207-209 Fore St.

2 Unit Condo.

Enclosed please find seven (7) sets of revised Site Plans and Subdivision Plans, full size Architectural Plans and colored renderings. The site plans and subdivision plans are being resubmitted as two separate sets of plans. The parking structure accompanying sectional subdivision plan will be the first phase of this project. The townhouses and accompanying sectional subdivision plan will be the second phase. We have incorporated revisions into the plans as follows:

**Project:** 05090  
**To:** William Needelman, AICP, Senior Planner, City Portland,  
**From:** John Q. Adams, P.E., PTOE, Senior Transportation Engineer  
Sebago Technics, Inc.  
**Date:** July 23, 2010  
**Subject:** Requested Traffic Analysis  
Old Port Hospitality, LLC - Phase 2  
Fore Street, Portland

SCALE: NTS  
 DATE: 07/22/2010  
 SHEET: Fig. 1

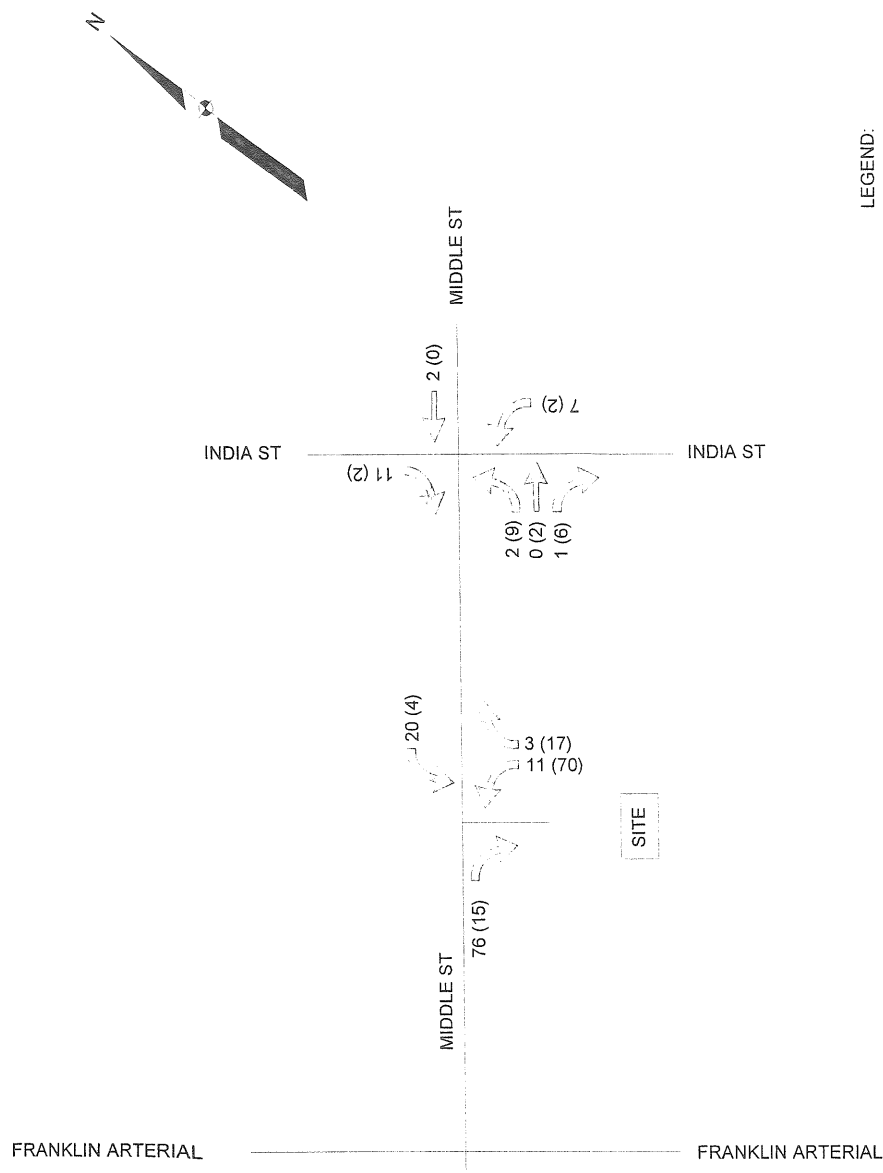
*Response: We have reviewed our traffic counts from July 21<sup>st</sup> and made some adjustments. These are shown in Figure 1. We have also attached a copy of the Temporary Traffic Control Plan that was in effect on the date of our traffic counts. It appears from the plan that more vehicle traffic may have been using the intersection of Middle Street at India Street due to Fore Street being closed to thru traffic and only open for local traffic. With this condition in effect we still felt the traffic counts would be valid and may provide a more conservative analysis.*

SCALE: NTS  
 DATE: 07/22/2010  
 SHEET: Fig. 3

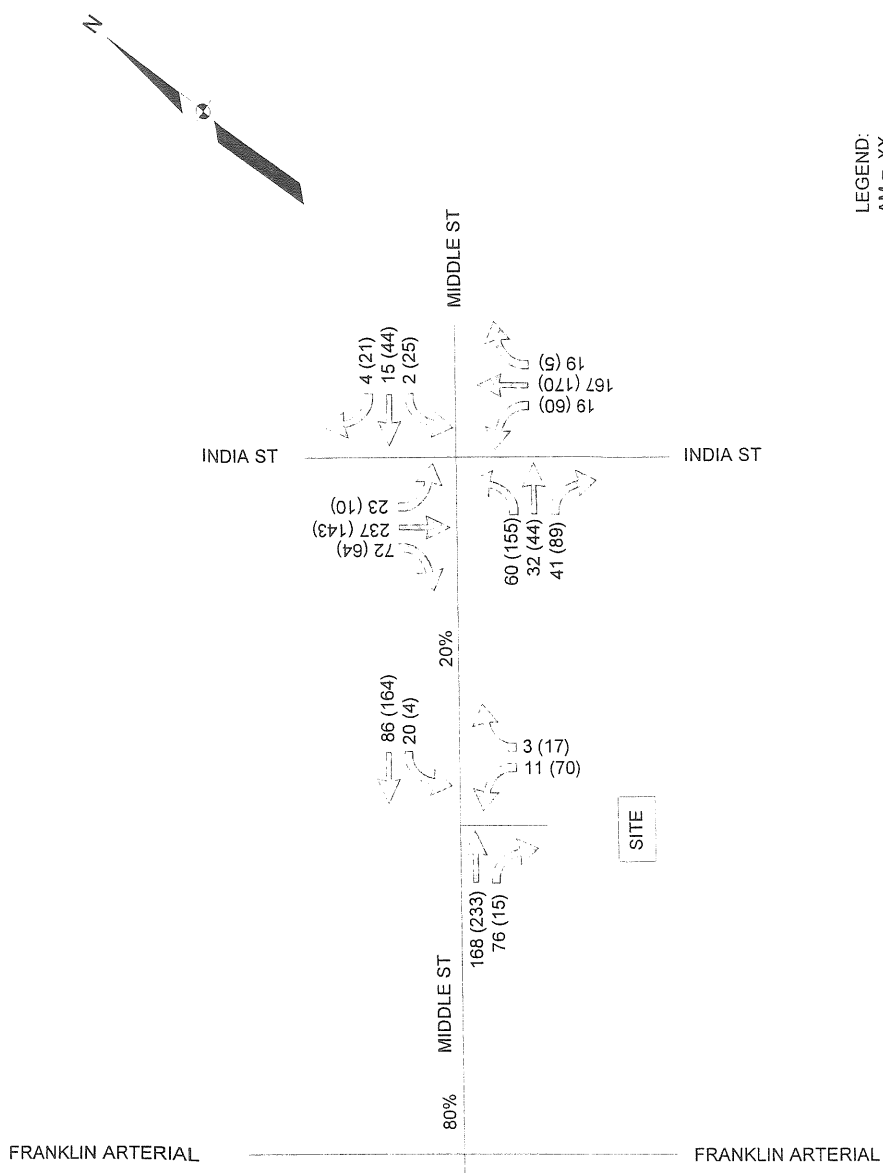
*Response: We have included other development trips for the Riverwalk and Bayview projects. The other development trips are shown in Figure 3 enclosed at the end of this report.*

<b>SCALE:</b>	NTS
<b>DATE:</b>	07/22/2010
<b>SHEET:</b>	Fig. 1

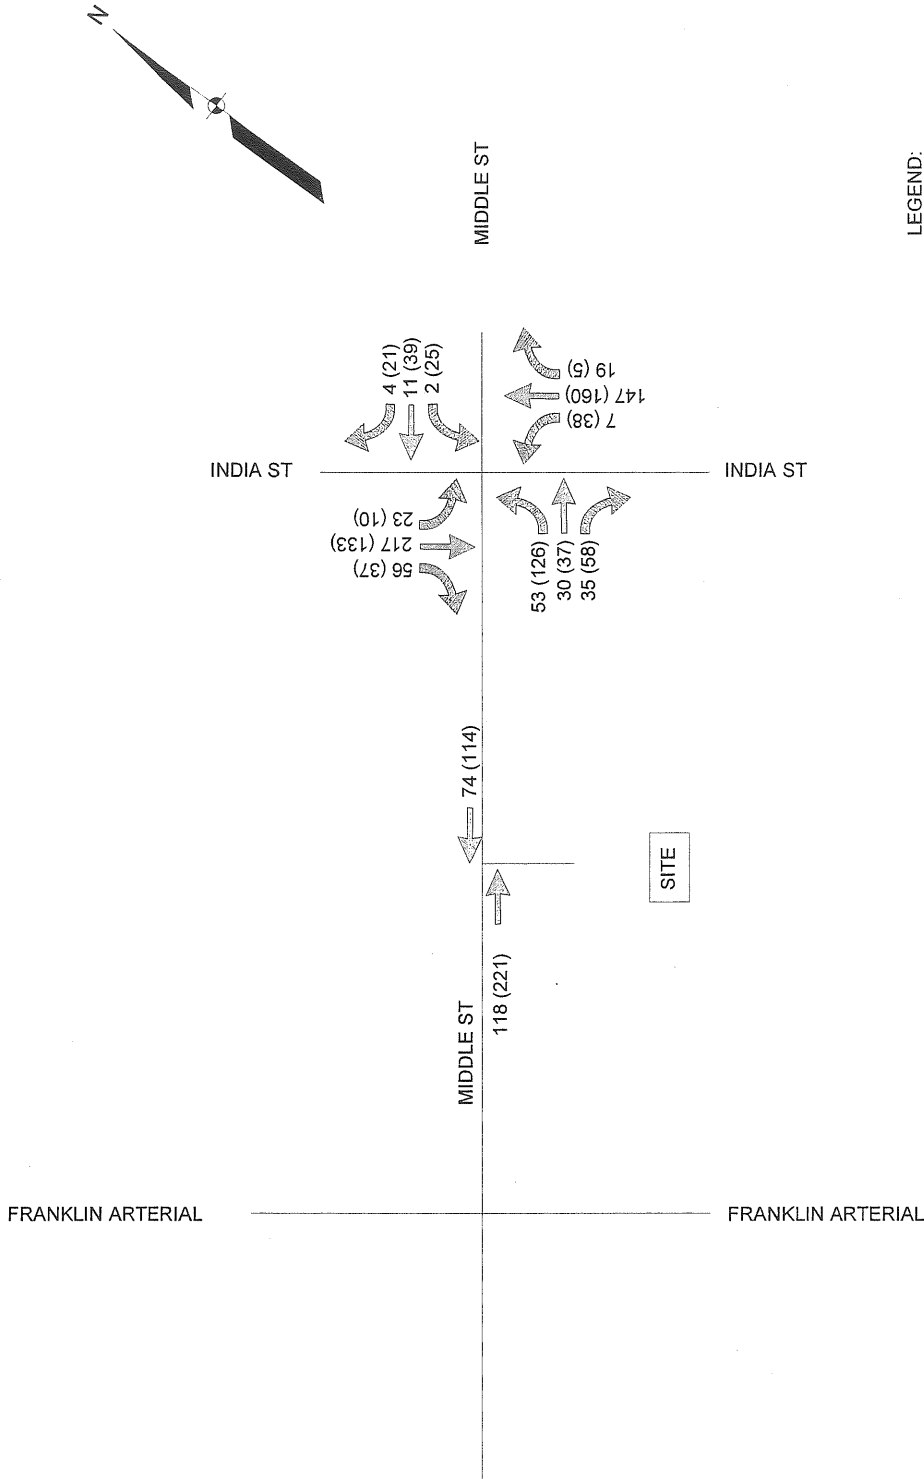
*Response: We have reviewed our traffic counts from July 21<sup>st</sup> and made some adjustments. These are shown in Figure 1. We have also attached a copy of the Temporary Traffic Control Plan that was in effect on the date of our traffic counts. It appears from the plan that more vehicle traffic may have been using the intersection of Middle Street at India Street due to Fore Street being closed to thru traffic and only open for local traffic. With this condition in effect we still felt the traffic counts would be valid and may provide a more conservative analysis.*

SHEET: Fig. 3

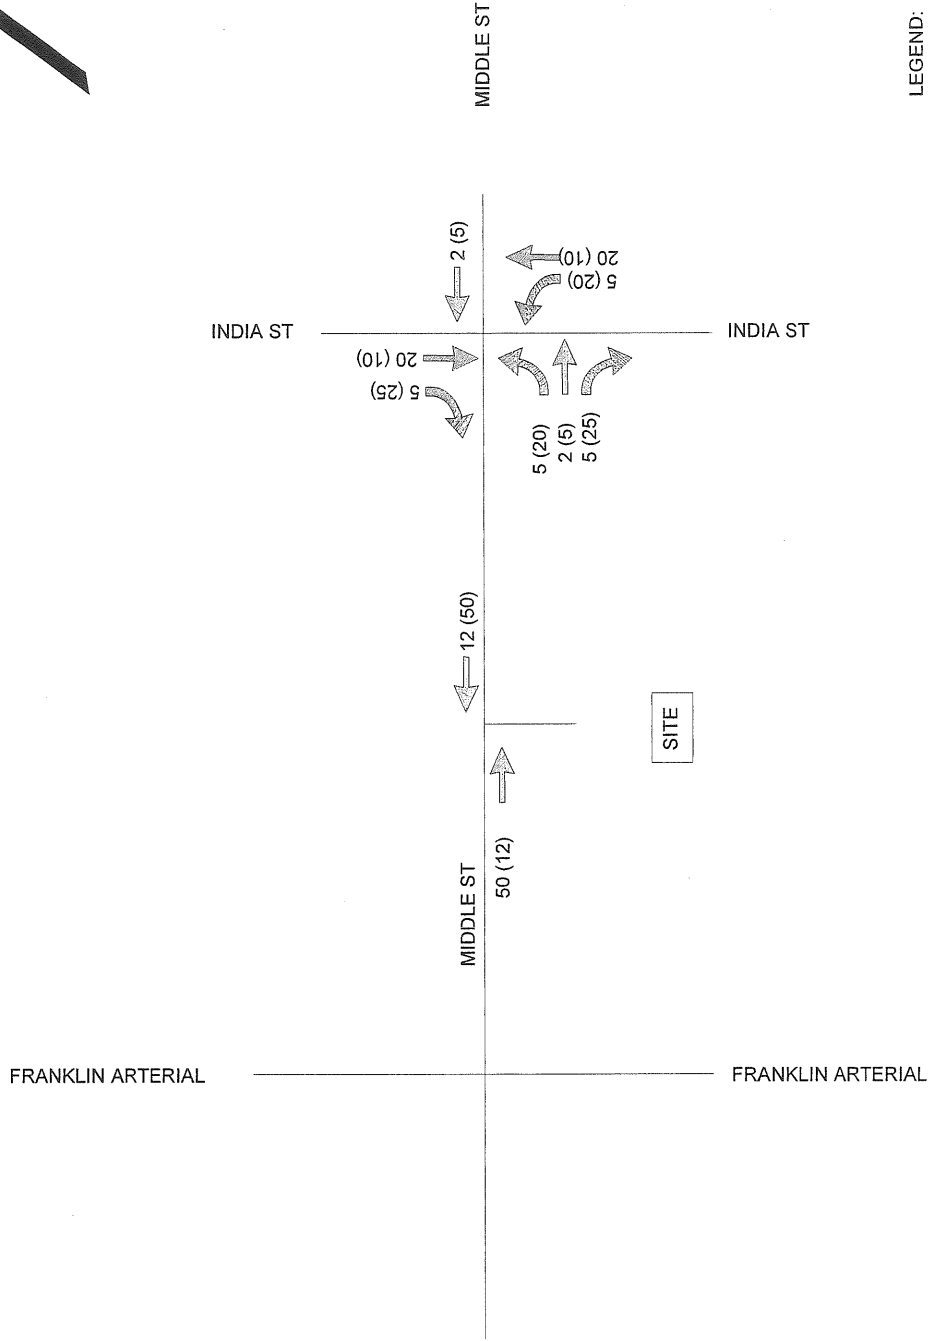
*Response: We have included other development trips for the Riverwalk and Bayview projects. The other development trips are shown in Figure 3 enclosed at the end of this report.*
